**Fieldhouse HVAC Replacement
NAU Project #09.300.251
Hard Bid Procurement for Construction Services
May 7, 2026**

ADDENDUM #3

M300

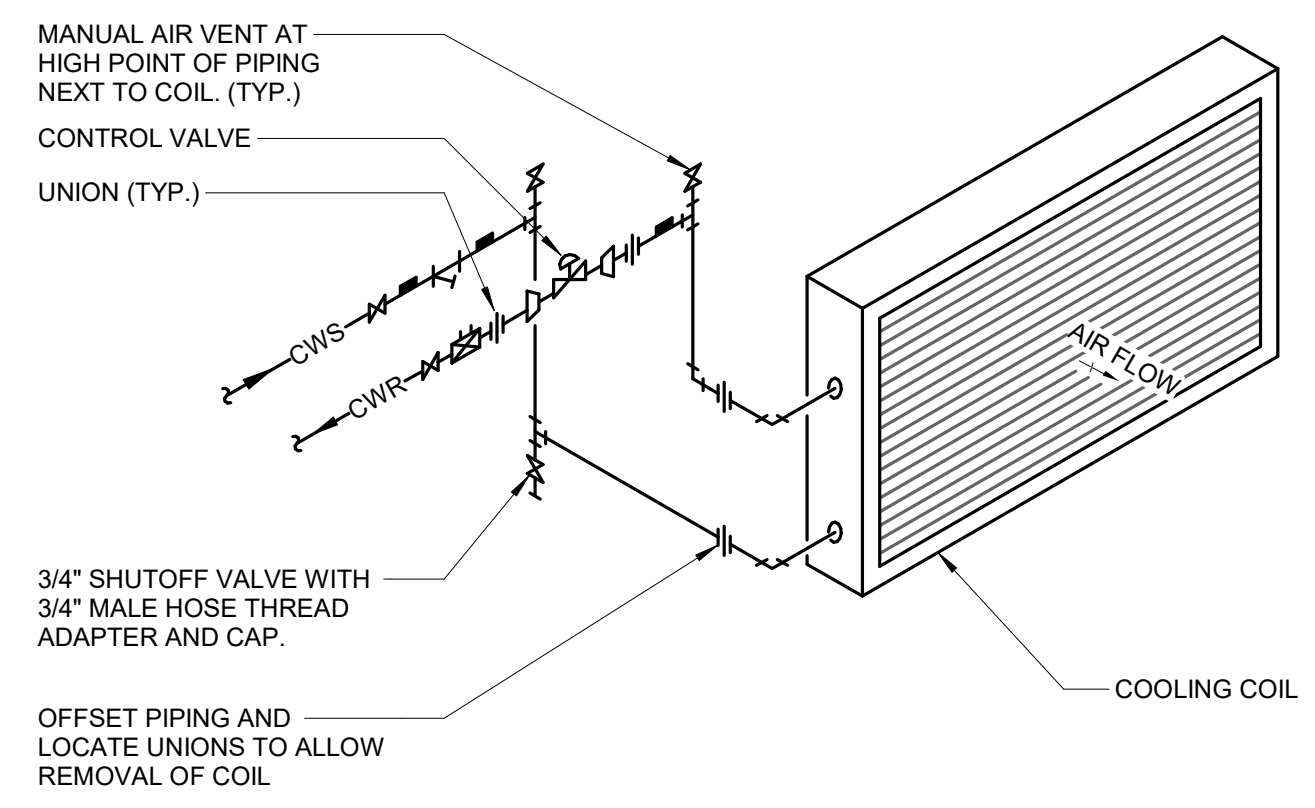
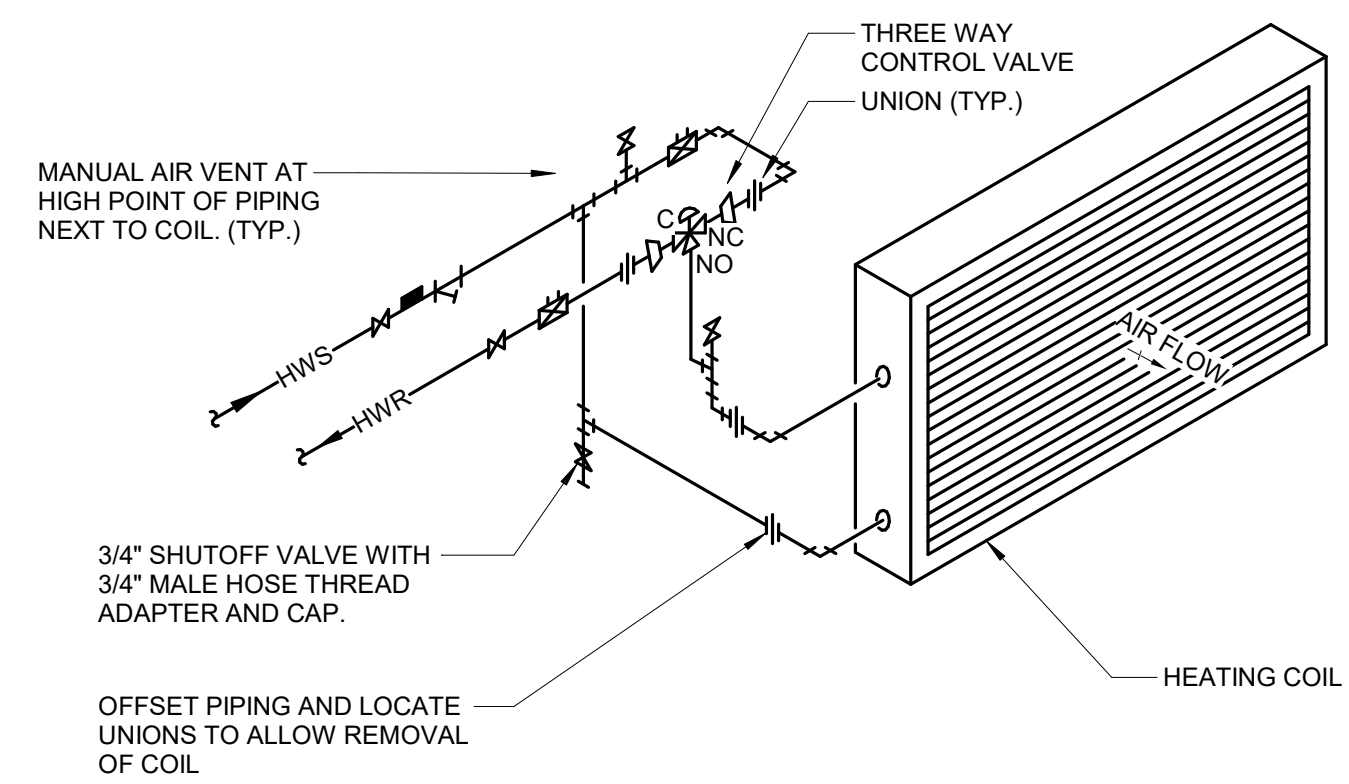
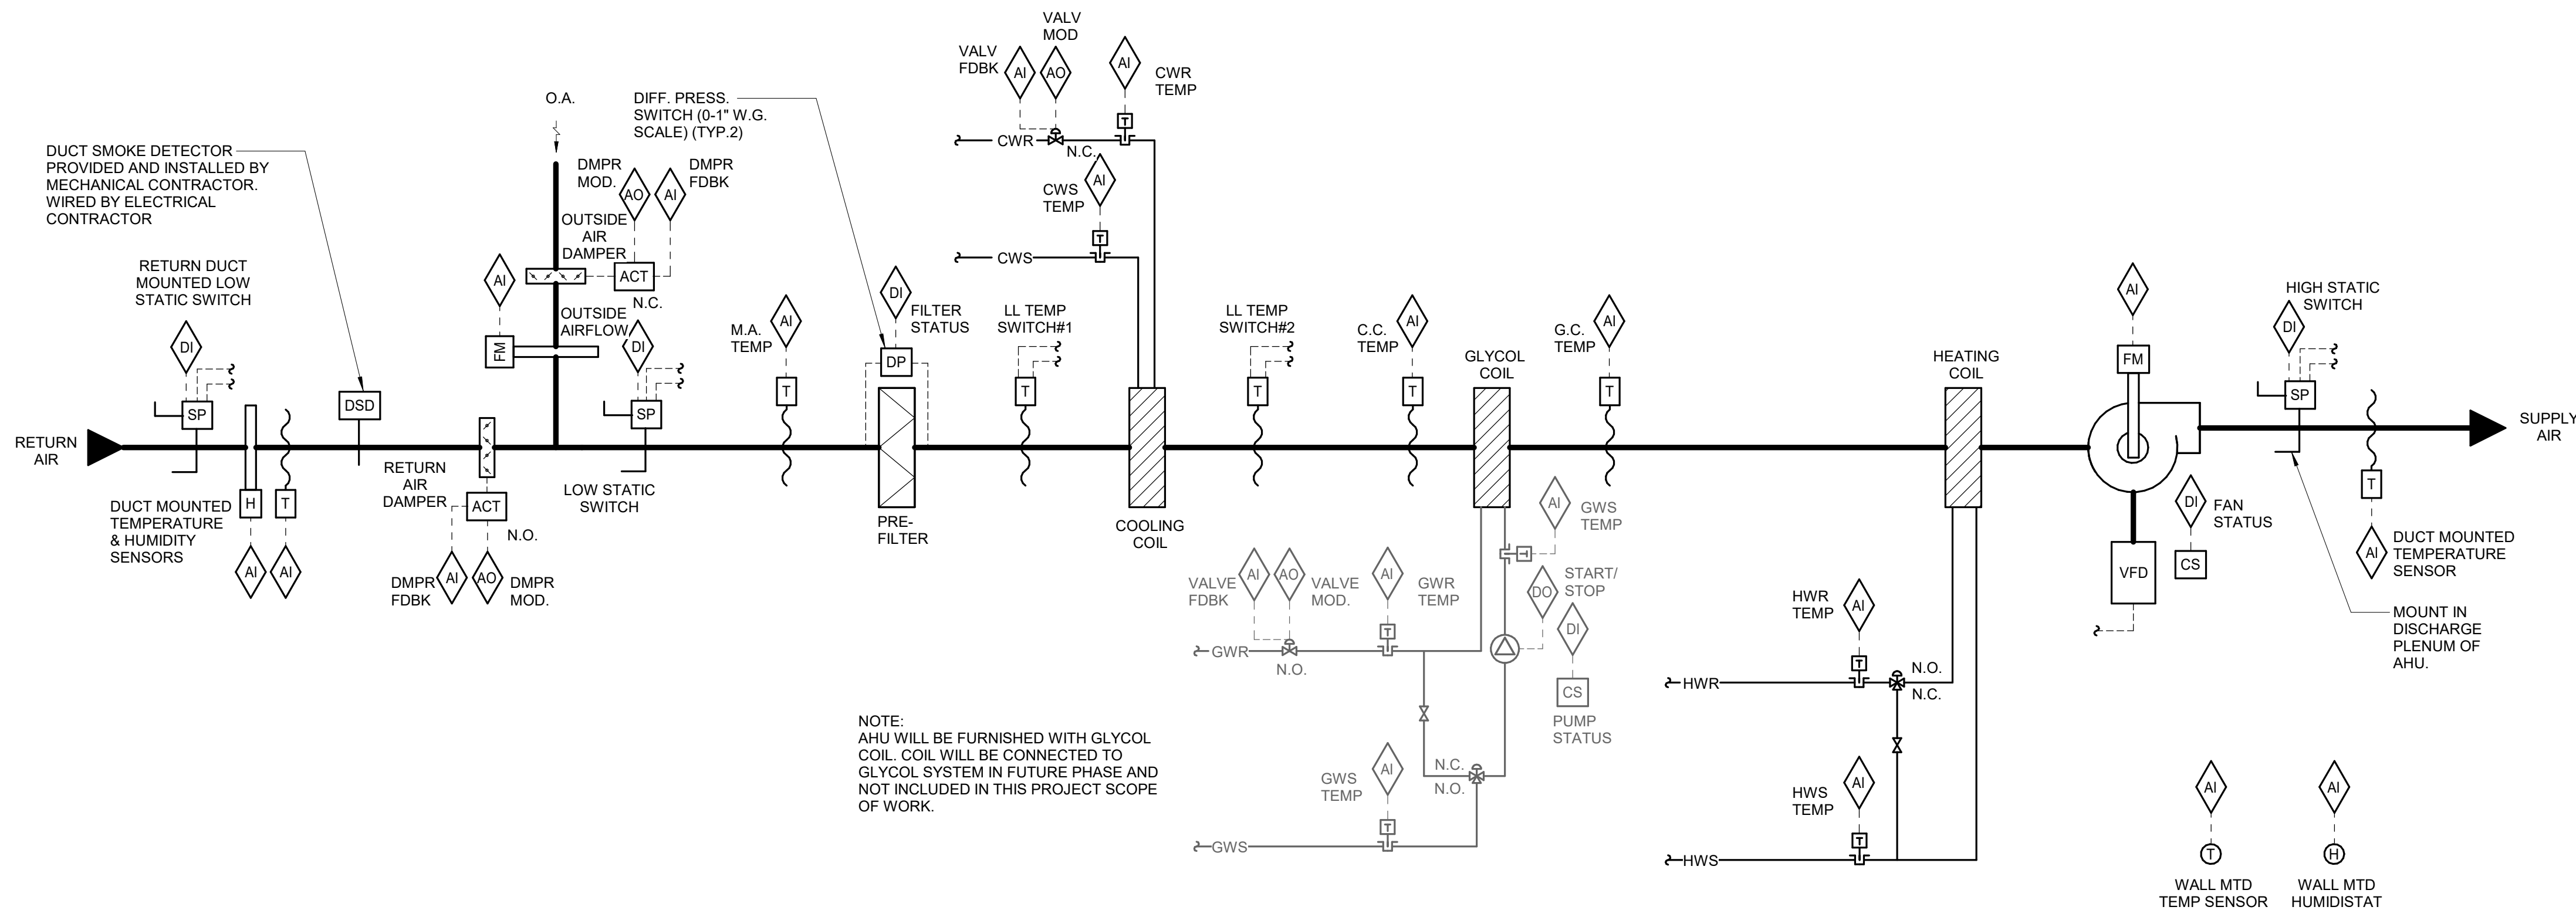
- c. Sheet M3.00 – Updated this sheet to include revised ventilation calculations and added notes to clarify outside air requirements.
 - d. Sheet M3.01 – Revised this drawing to provide a new Sequence of Operations to clarify the control scheme of the unit. Added a general note to provide controls meetings with NAU.

VENTILATION CALCULATION (IMC_2021)

VENTILATION CALCULATION NOTES:
 1. THE CALCULATION ABOVE WAS PRODUCED USING THE TOTAL AREA OF THE FIELDHOUSE, RAN AS A "GYM, STADIUM, ARENA (PLAY AREA)" PER IMC 2021.
 2. OUT OF THE 16529 CFM OF OUTSIDE AIR REQUIRED, 13500 IS PROVIDED BY HV-1 AND E-HV-1/E-HV-5 WILL EACH PROVIDE 1515 CFM OF OUTSIDE AIR FOR A TOTAL OF 16530 CFM OF OUTSIDE AIR.
